DESCRIPTIVE REPORT

Sheet No. C 6204

Hudson River

REVIEW OF TOPOGRAPHIC SURVEY NO. 6204 (1934)

SECTION OF TOPOGRAPHIC SURVEY NO. 6204  
FIELD LETTER "C"  
HUDSON RIVER  
Applied to T-6204  
A.F.J. 4/1/38  
SCALE 1:5000

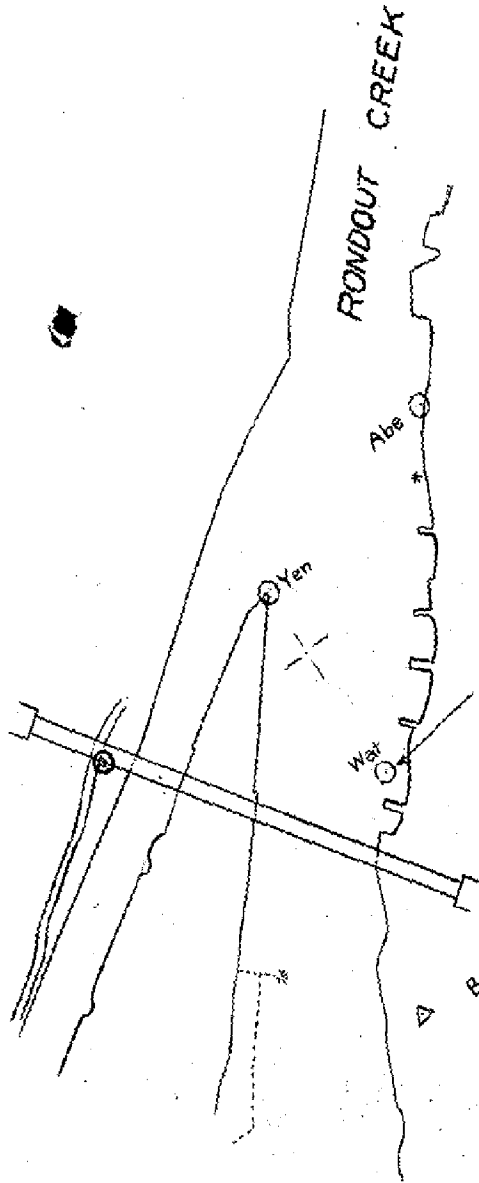
Inclosed is a tracing of a section of your sheet T-6204,  
Hudson River, on which is shown signal WAT. As this signal is  
outside the high water line, information is desired as to the  
character of this feature in order that it may be properly  
charted.

- a. Clearances of bridges are not given.
- b. Features above high water were described with slanting letters, whereas the manual calls for the use of vertical lettering.
- c. The projection lines were left in pencil pending adjustment of triangulation. This has now been inked in the office. (See D.R. page 2).
- d. Signal "Wat", lat.  $41^{\circ}54.95$ , long.  $73^{\circ}59.0'$  is outside of the H.W. line without any description of its character. This matter has been referred to the field party.

Information received & applied to sheet. A.F.J.
